Caavo Labs India

Document: Vendor Schematic Review

Design name: CAVECSSH00E00

Page no: 5 IWR POWER

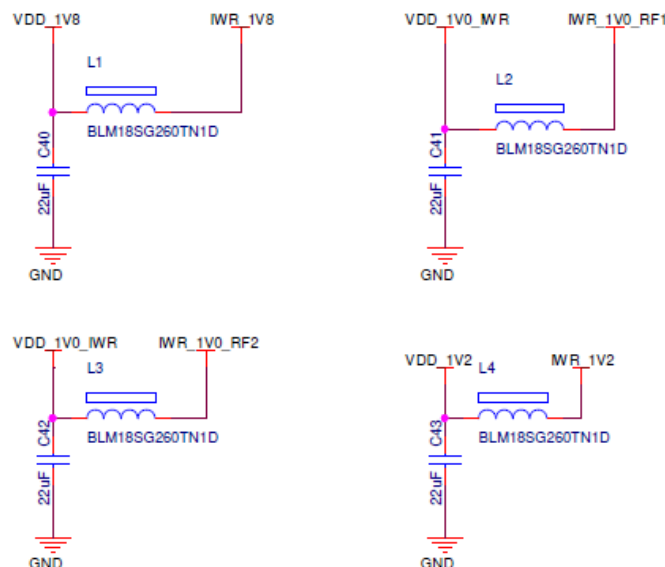
Q2. We are using a DCDC regulator instead of the PMIC. We are using a bead (BLM15PD300SZ1D) on 1.2V and 1.8V. Do we have to provide an LDO bypass circuit for 1.2V and 1.8V?

Page no: 7 AM IO

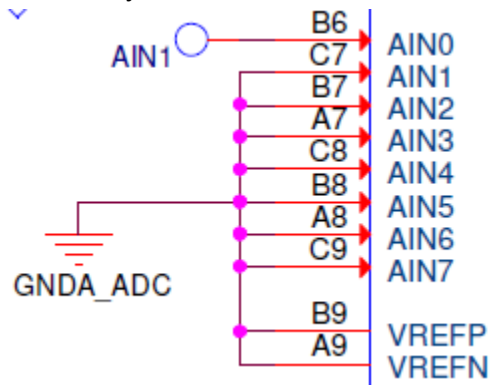
Q3. We are not using ADC functionality so we have connected ADC VREFP/N to GND, is it OK?

Page no: 7 AM IO

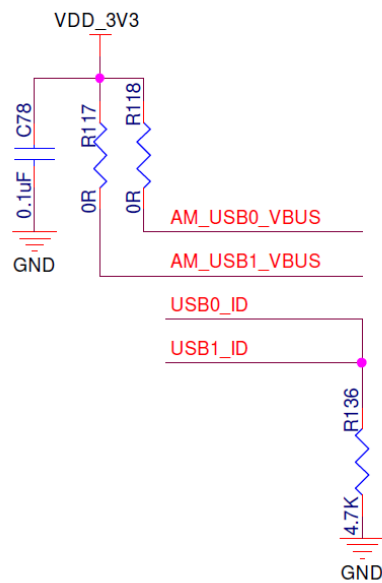
Q4. We are not using USB functionality so we have connected USB ID to GND and USB VBUS to 3.3V, is it OK?
